TM	CS	SPE	CIF	<u>FIC</u>	ATI	ON		NO. S	1202			_
REV: Ø														
COMPILED:			CHEC	CKED:				APPD:	Mon	SHEET	1.	OF	6	
TITLE'S K	IT 34	1

Modification of MSA-1

A. MUTING OF MSA-1 during transmission

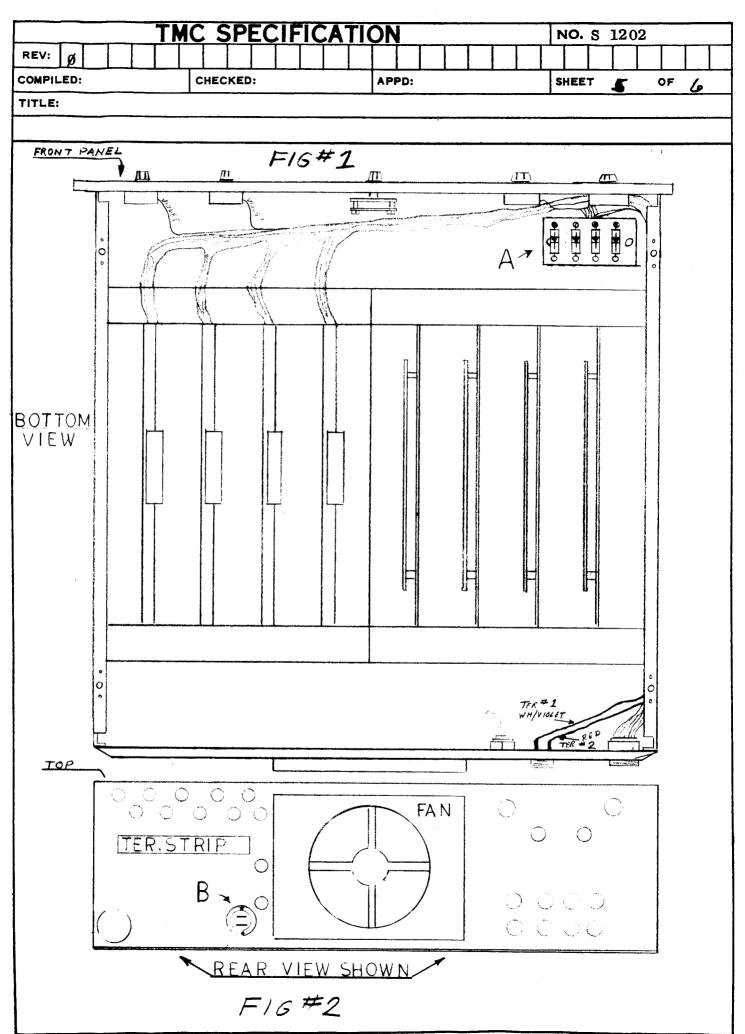
- 4. Remove top and bottom covers from MSA-1.
- 5. Drill two (2) 11/64" holes as shown in figure #1A for terminal board (A-4211-4).
- 6. Drill two (2) 9/64" holes as shown in figure #2B for connector (JJ-119-4).

- 7. Mount terminal board in 11/64" holes (A-4211-3), with CA-1353 attached.
- 8. Mount JJ-119-4 in 9/64" holes as shown in figure #2B, utilizing SCFPO440BN5, LWEO4MRN, and NTHO440BN4.

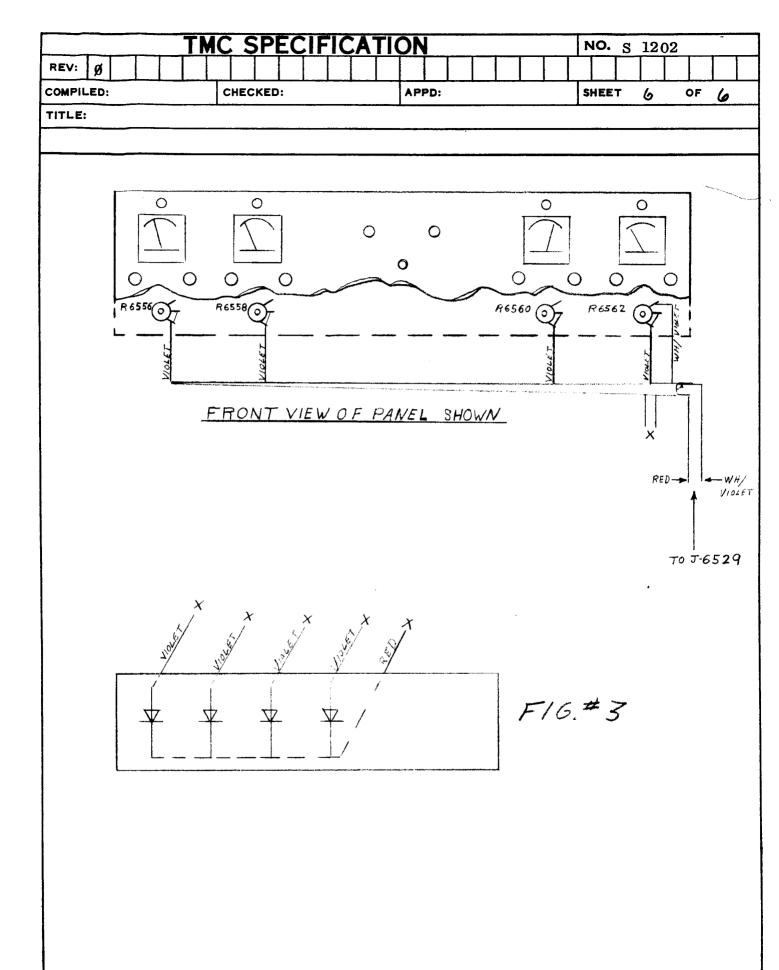
- 9. Dress leads of cable (CA-1353) to proper termination points as shown on figure #3 and solder all connections.
- 10. Lace cable (CA-1353) to main cable (CA-861) as shown on figure #1.
